East Reading Mass Rapid Transit Scheme

Water Framework Directive Compliance Statement

Project Ref: 28791/4005 | Rev: C | Date: October 2018

SECTION A-A
TIMBER PLATFORM FOR TEMPORARY MOORING
1:25

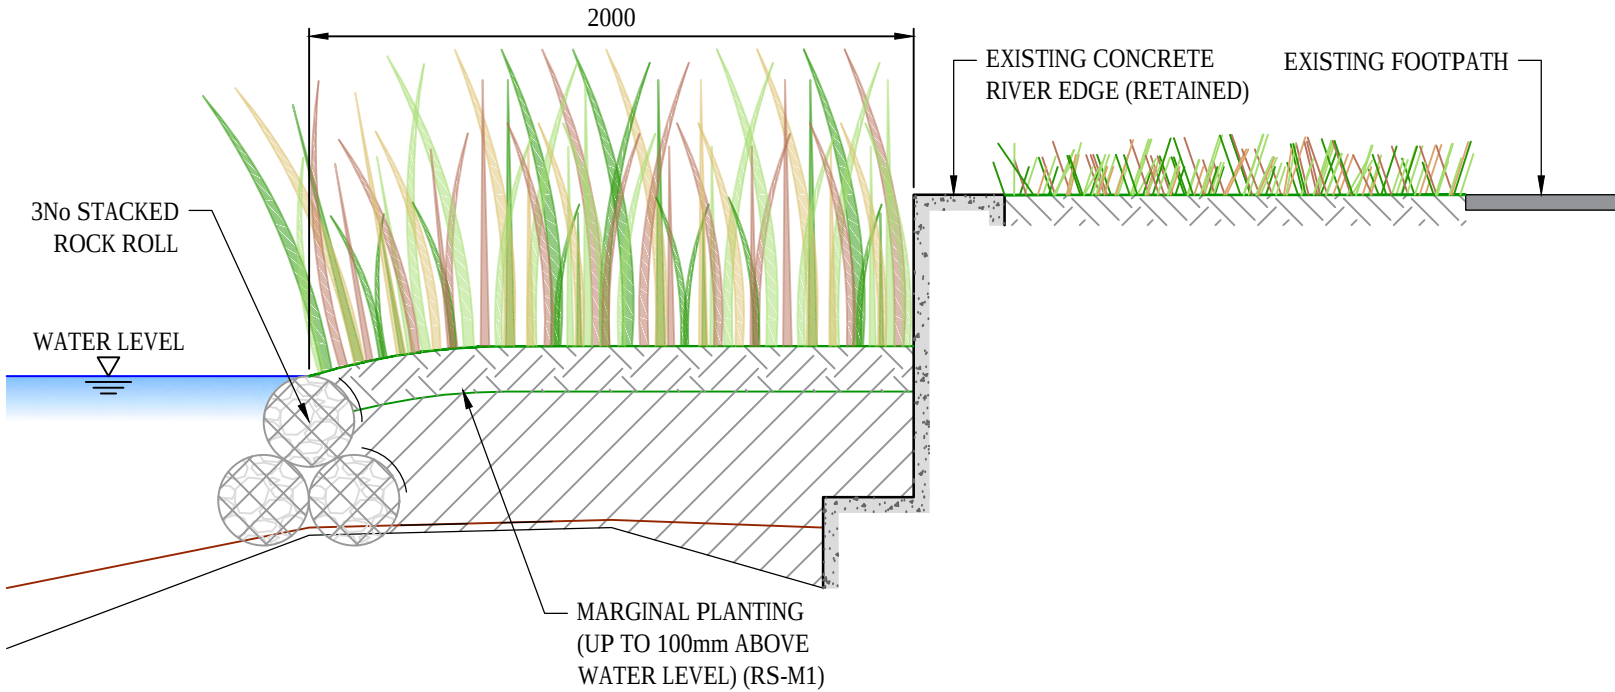
With regard to the marginal shelves, willow spiling is shown in Section A-A on drawing number 28791/4001/013 Rev P01 (Proposed Mooring Platforms/Marginal Planting Shelf). If this is done using live willow, this is likely to grow, shading out the

marginal plants and adding to the required maintenance. Dead willow or hazel could be used as an alternative.
